**RE: Los Diamantes
Revised Grading and Drainage Plan
Stamp Date 12-22-2016 (File: N09D013)**

**Re: REVISED Los Diamantes Subdivision Grading and Drainage Plan
Revised Engineers stamp date 12-22-16 (N09/D013)**

LOS DIAMANTES SUBDIVISION GRADING & DRAINAGE PLAN

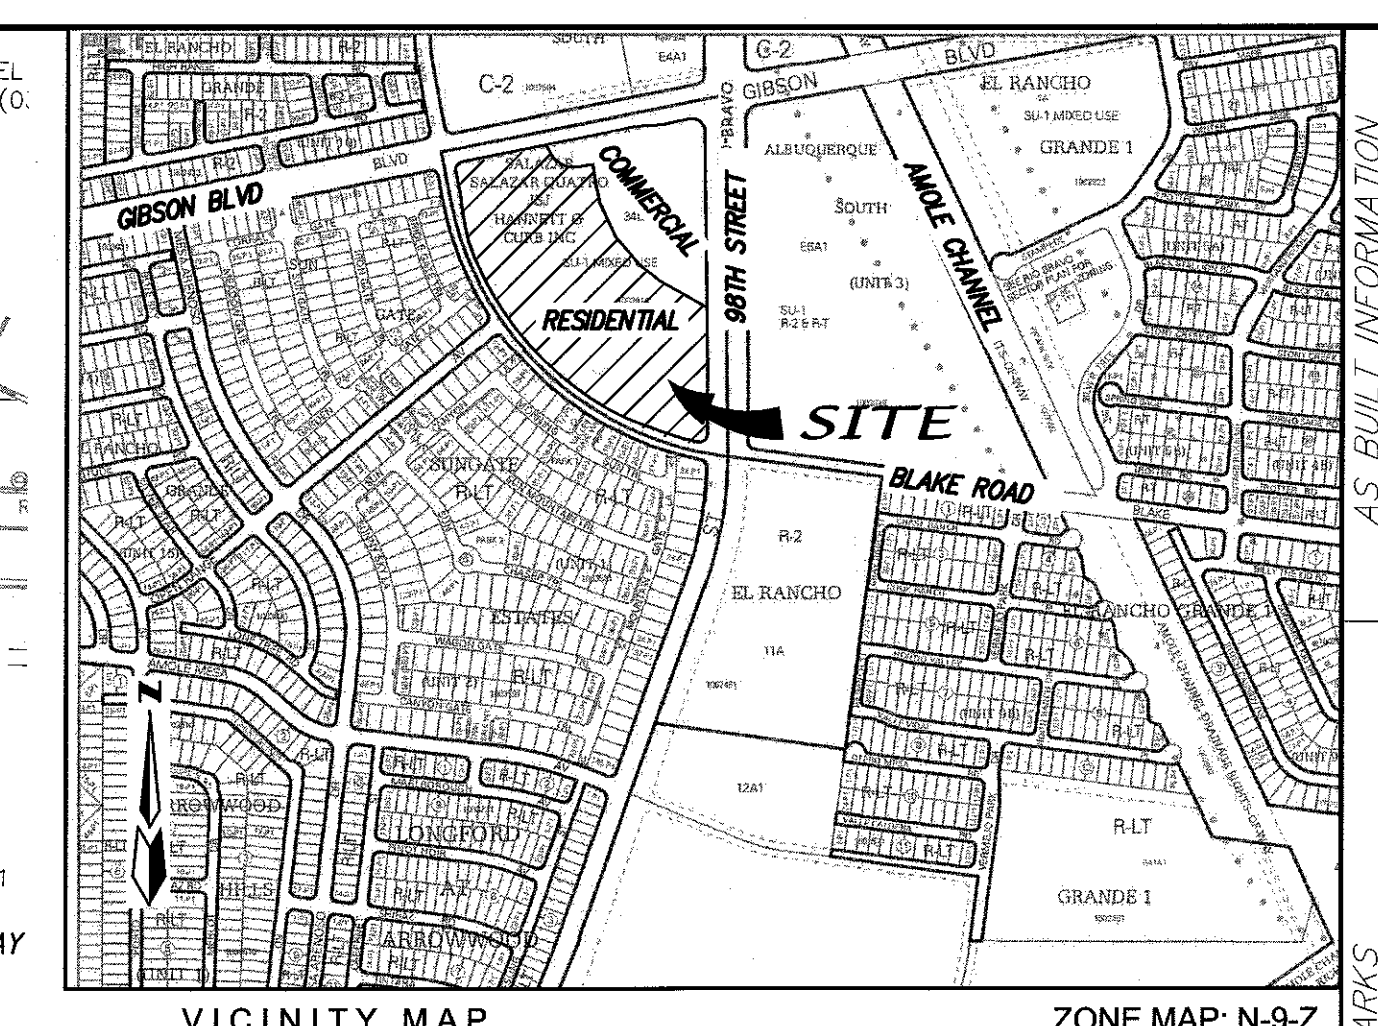
Based upon the information provided in your submittal received 12-23-2016, the above referenced Plan is approved for Grading Permit with the minor changes to the proposed pad elevations. We understand that the side yard slopes have been increased from 0.6% to 1%, and minor revisions to reflect final DRC plans are included.

Certification per the DPM will be required prior to Pad Cert/ROFG.

The only revision is the side yard swale slopes have been increased to 1.0% and the pads raised accordingly.

The storm drain was revised to reflect what was designed and approved at DRC.
